**ADDENDUM NO. 1**

**RE: Item #1, March 5, 2025 Letting - IM 0909(92)387, PCN 06G8, Minnehaha County - Interchange Reconstruction, Structure (258' Steel Girder Bridge), PCC Surfacing, Sidewalk**

**GRANULAR BRIDGE END BACKFILL, BASE COURSE, AND GEOGRID REINFORCEMENT**

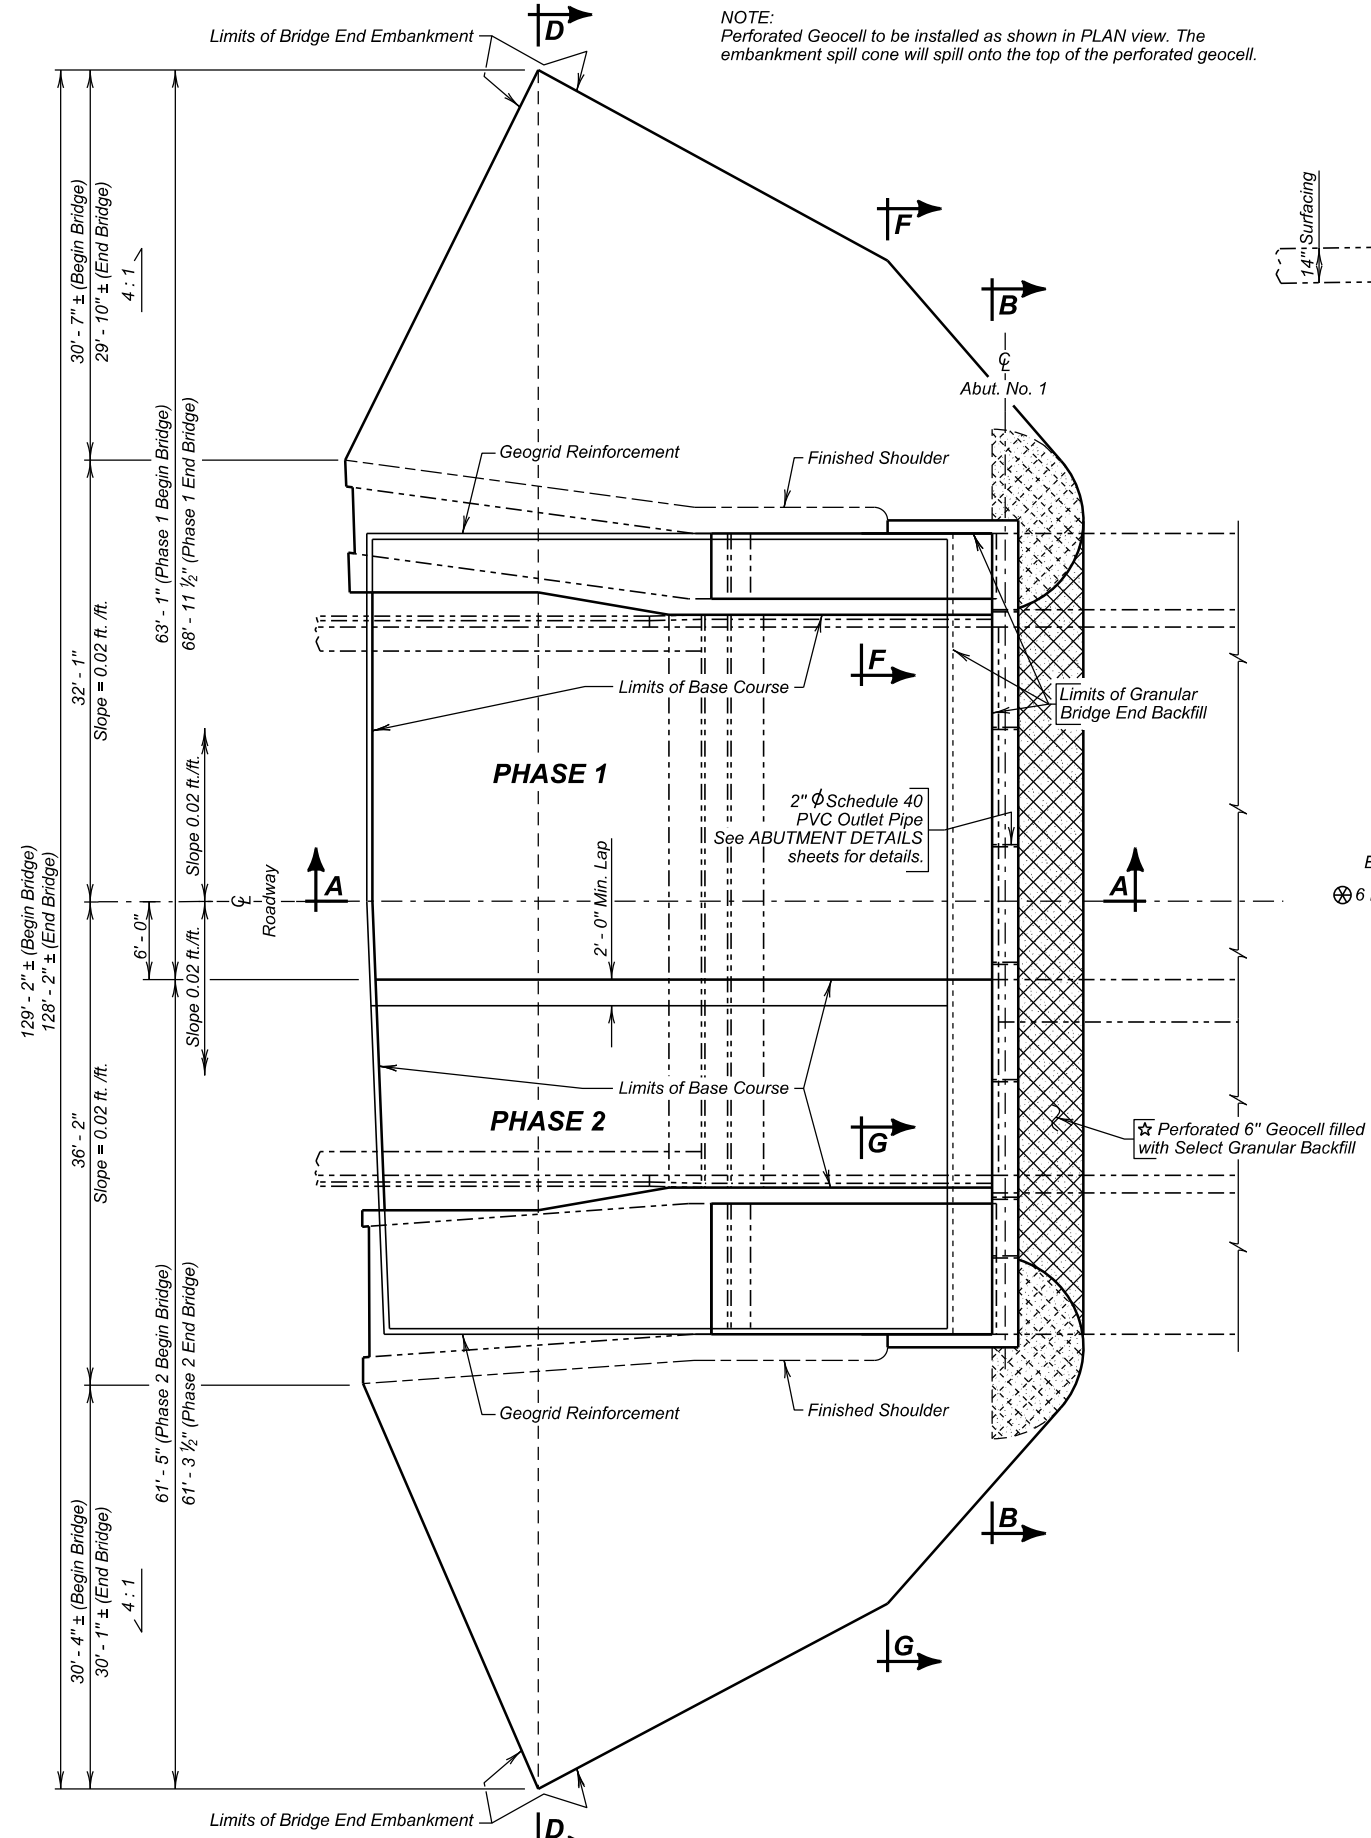
**Sheet E5-E8:** Note placement was adjusted and GRANULAR BRIDGE END BACKFILL, BASE COURSE, AND GEOGRID REINFORCEMENT note was added.

- The Geogrid Reinforcement will be a biaxial grid of single layer construction. Vibratory welded, integrally formed or woven and coated geogrids will be acceptable. Grids with laser welded grid junctions will not be allowed. The Geogrid Reinforcement will be certified by the supplier to meet the following specification prior to installation:

Property	Test	MARV
Wide Width Strip		
Tensile Strength	ASTM D 6637	850lb/ft MD and XD
Ultimate

- Geogrid Reinforcement will be paid for at the contract unit price per square yard for Geogrid Reinforcement. Payment quantities will be based on area covered plus 15%. Overlaps are accounted for by the additional 15%. Payment will be full compensation for furnishing and installing the Geogrid Reinforcement only. Granular backfill materials will be paid for under a different bid item.
- Granular Bridge End Backfill will conform to Section 882 of the Specifications.
- Granular Bridge End Backfill will be paid for at the contract unit price per cubic yard in accordance with 430.5 of the Specifications. Payment will be full compensation for furnishing and placing this material.
- Base Course material will conform to the specification for Aggregate Base Course in Section 882 of the Specifications.

- The Geogrid Reinforcement will be placed on a level surface and overlapped a minimum of 2 feet.
- The Geogrid Reinforcement will be placed as taut as possible with minimal wrinkles. Placement will be done so that subsequent granular cover material does not shove, wrinkle, or distort the in-place Geogrid Reinforcement. The overlaps will be shingled in a manner that assures granular material will not be forced under the geogrid during backfilling operations. The Geogrid Reinforcement may be held in place with small piles of granular material or staples.

- Base course will be dumped at least 20 feet behind the leading edge of the backfill and pushed into place with a loader or dozer from the covered areas to the uncovered areas. Traffic will not be allowed on the uncovered geogrid.

- Granular Bridge End Backfill, Base Course, and adjacent soil embankment will be built simultaneously in horizontal layers. Base course will be placed in 6-inch maximum lifts and compacted to 97 percent of maximum standard proctor dry density using a smooth face vibratory roller or vibratory plate compactor. Each layer of granular material will be thoroughly watered prior to and during compaction.

- Density tests within the berm limits will consist of tests conducted both in the soil embankment and the granular bridge end backfill according to the modified zone requirements below:

Zone	Depth (ft.)	Min. required tests
1	0-1	1
2	1-3	1
3	3-5	1
4	5 to Bottom	1 per 3 vertical feet

- The zone requirement will be enforced for all phases of staged construction. For example, if the berm on the west side of centerline is constructed separately from the east side, testing by zone will be required on both sides of centerline.

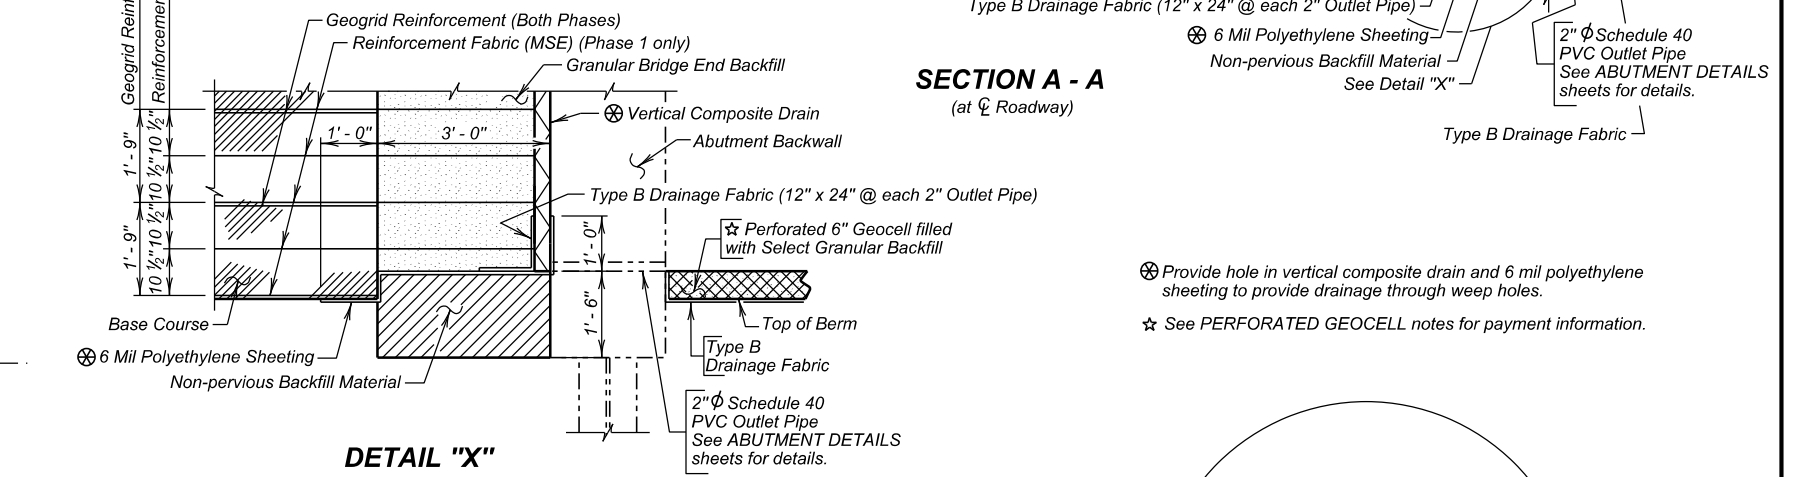
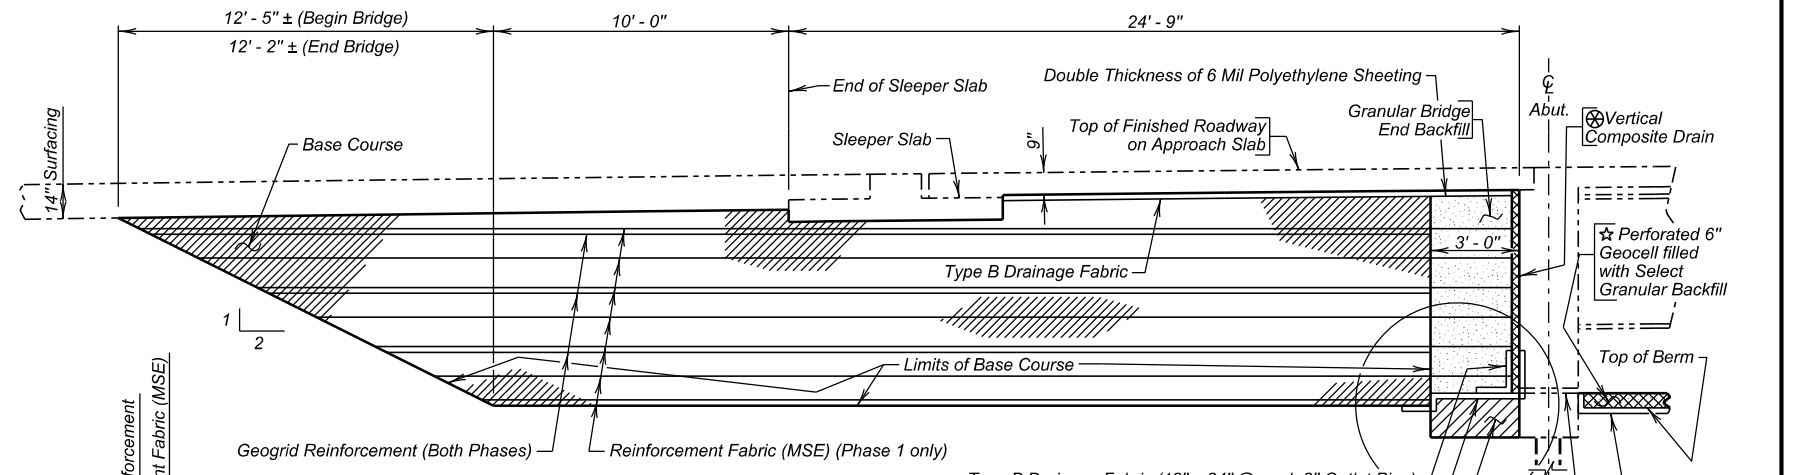
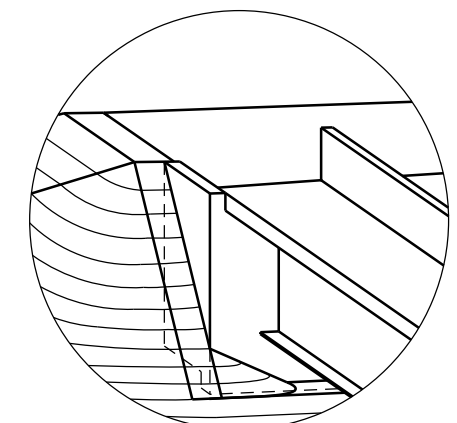
**Sheets E34 & E35:** DETAILS OF BRIDGE END BACKFILL sheets were revised.

NOTE:  
Perforated Geocell to be installed as shown in PLAN view. The embankment spill cone will spill onto the top of the perforated geocell.
